CITY OF COCONUT CREEK

DEVELOPMENT REVIEW COMMITTEE (DRC) REVIEW #4 – JULY 1, 2026

PROJECT NAME:	Walmart Expansion		
PROJECT NUMBER:	PZ-25090001		
LOCATION:	5571 W Hillsboro Blvd		
APPLICANT/AGENT:	Bowman Consulting		
REVIEW/APPLICATION:	Site Plan for an approximate 5,000 sq. ft. addition		
STATUS:	Submit for DRC sign-off		
DISCIPLINE	REVIEWER	EMAIL	TELEPHONE
DRC Chair Planning and Zoning	Deandrea Moise - Planning Manager	dmoise@coconutcreek.net	(954) 973-6677
Resilient Design and Development	Liz Aguiar- Assistant Director	laguiar@coconutcreek.gov	(954) 973-6756
Resiliency & Photometrics	Linda Whitman – Resiliency Manager	lwhitman@coconutcreek.net	(954) 973-6756
Planning and Zoning	Natacha Josiah - Planner	njosiah@coconutcreek.net	(954) 973-6756
Transportation	Michael Righetti - Transportation Manager	mrighetti@coconutcreek.net	(954) 973-6756
Building	Sean Flanagan – Building Official	sflanagan@coconutcreek.net	(954) 973-6750
Engineering	Eileen Cabrera - Senior Engineer	ecabrera@coconutcreek.net	(954) 973-6786

C1.1 Site Plan

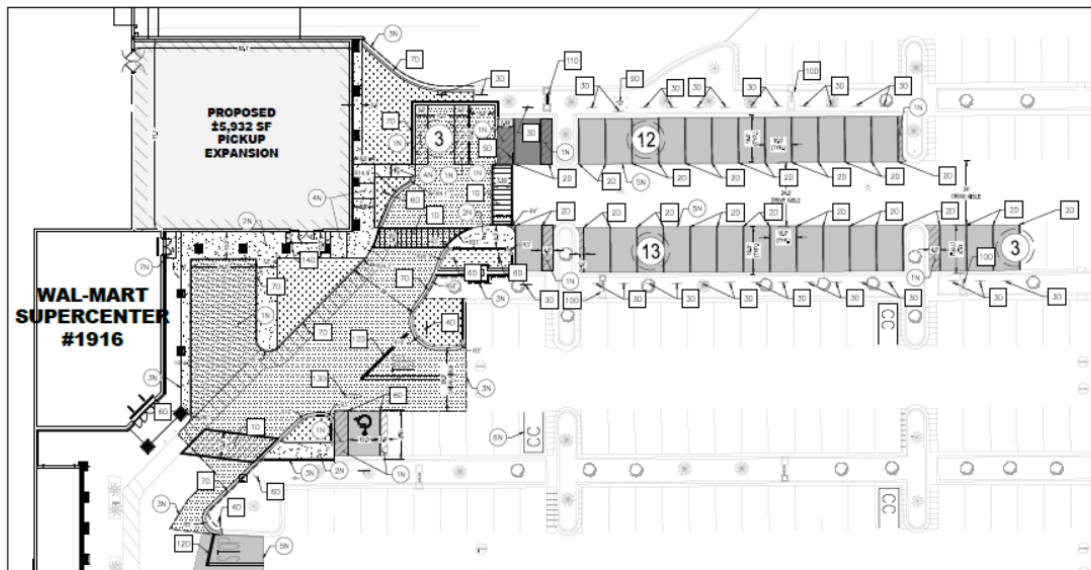
1. Provide data on the proposed lighting fixtures to be used in the parking lot.
 - Full cutoff fixtures utilizing LEDs are recommended.
2. Provide calculated photometric readings based on the proposed lighting fixtures for review.
 - This lot is an area where security is a concern since the applicant is a major retailer that is open late. The lot will be used for the transport and transfer of merchandise, including high value

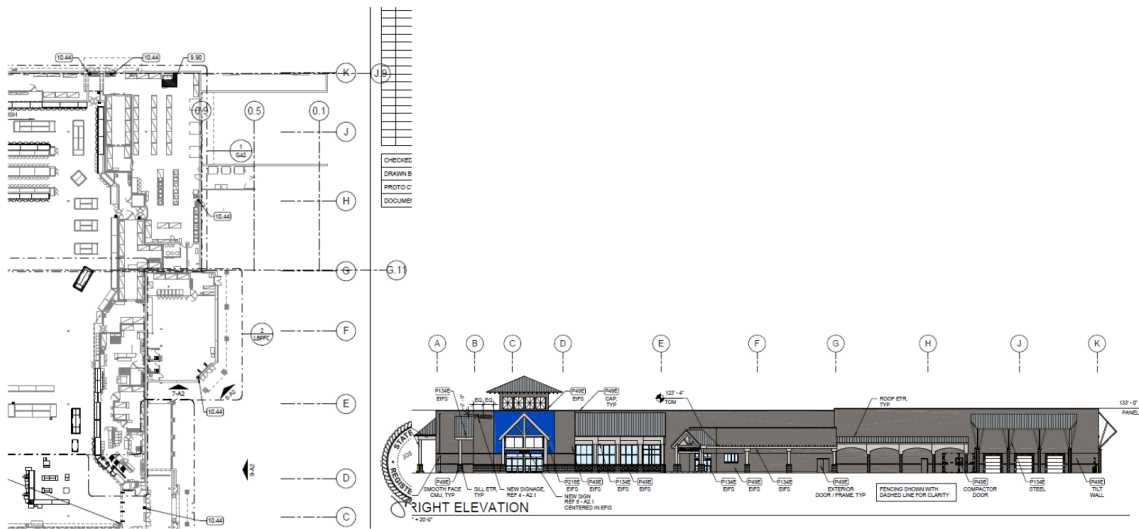
The first two pictures are from the 1916-251 you referenced; however. On the C1.1 Site Plan, you can see the addition jets out much further than the liquor store. The renderings on the 1916-251 don't reflect that. You can change the comment to say that the addition wasn't included in the color rendering on the 1916-251. We specifically are interested in seeing what the south wall of the addition will look like with the door that the employees will be using to enter and exit the addition.

Response: Please see the revised drawings.
